Change Order

PROJECT (Name and address):
City of Jonesboro New Facility
Sanitation and Street
Jonesbor, AR

CHANGE ORDER NUMBER: 001
DATE: October 14, 2010

CITY OF JONESBORO VEHICLE MAINTENANCE FACILITY JONESBORO, AR	FLOOR PLAN	STUCK associates ARCHITECTS <small>Jonesboro, Arkansas www.stuckarch.com (870) 932-4271</small>
Project Name: Jonesboro, Arkansas 1-328-096 1/8" = 1'-0"	Design: S. Smith Drawn: S. Smith Checked: S. Smith Date: 11/11/11

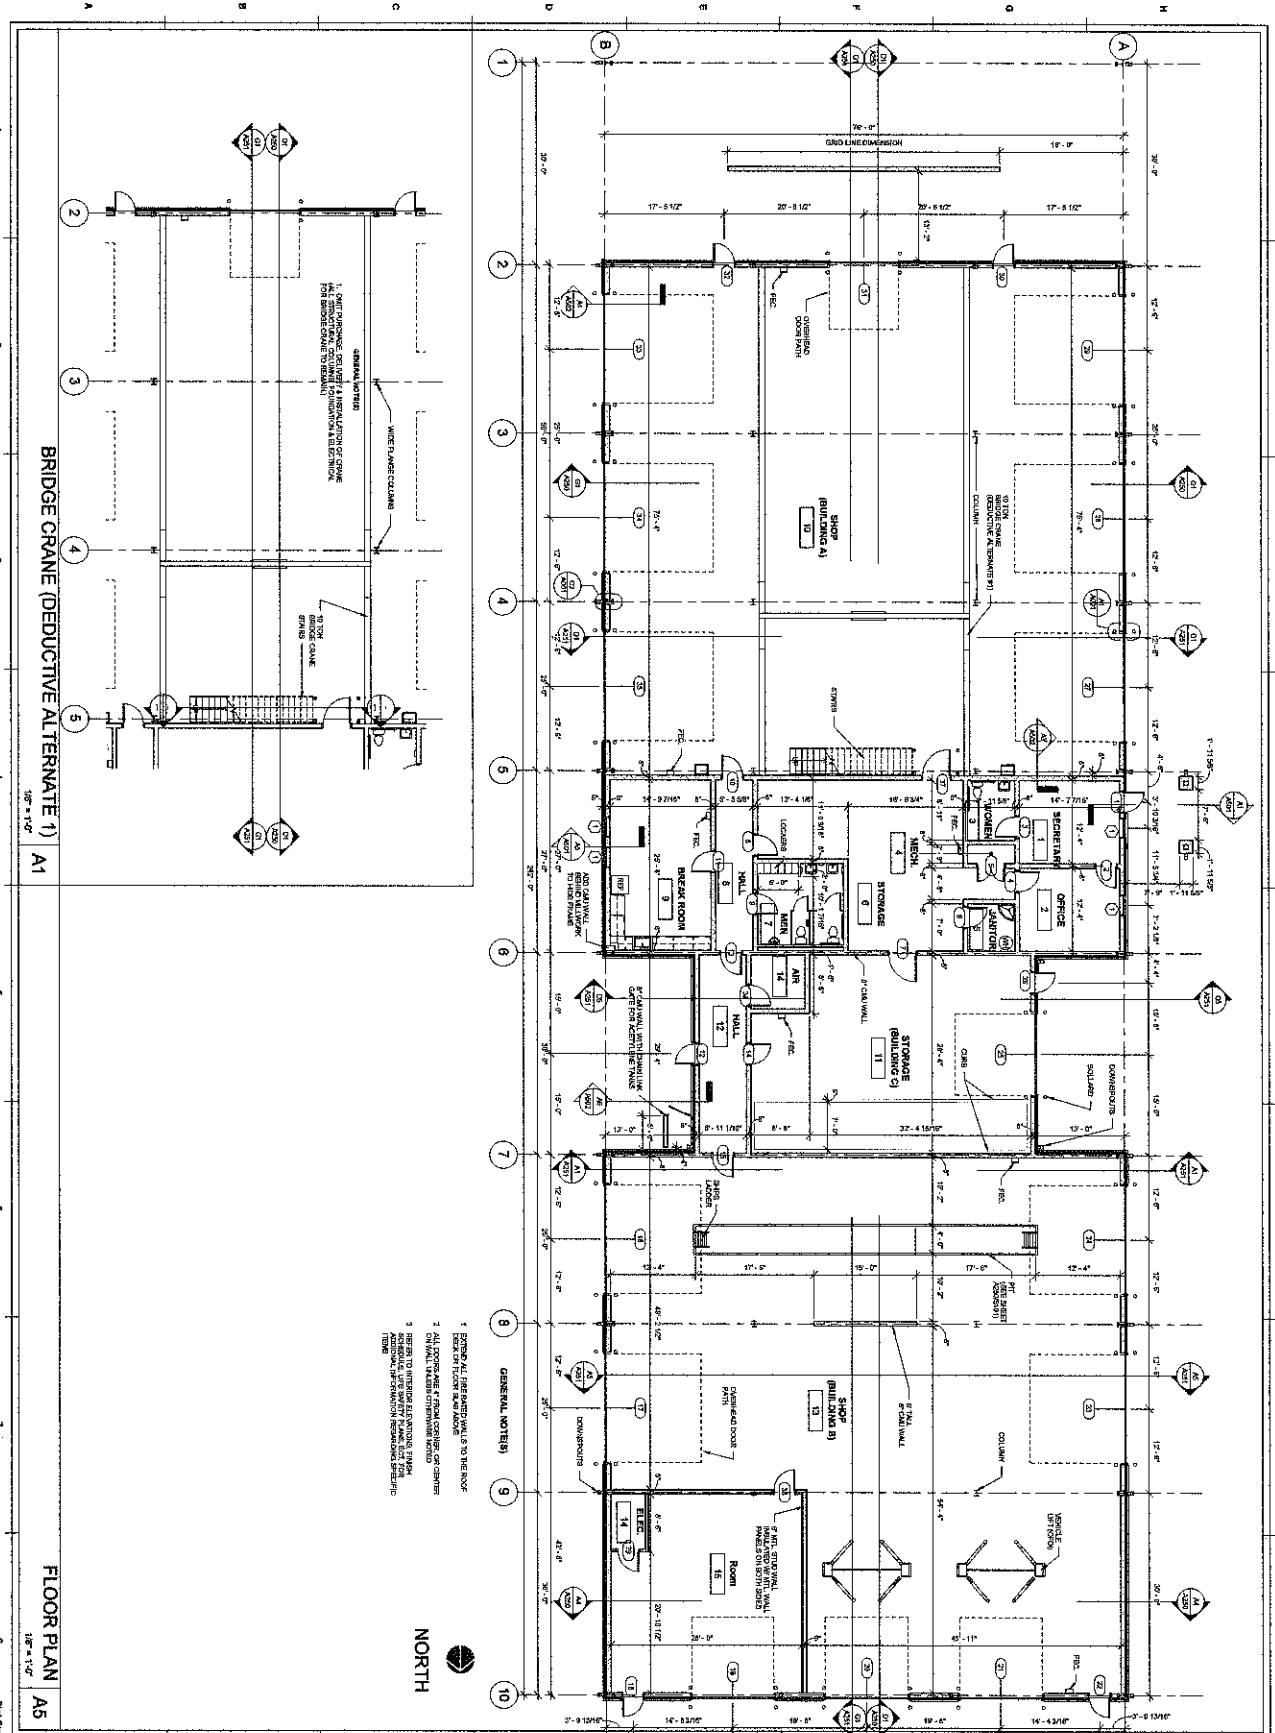
The 4" thick slab in grid lines 1 through 2 to be changed to a 8" thick slab. The 4" thick slab in grid lines 2 through 5 to be changed to a 8" thick slab. The 4" slab in grid lines 5 through 10 to be changed to a 6" thick slab. See attached drawing for grid line placements.
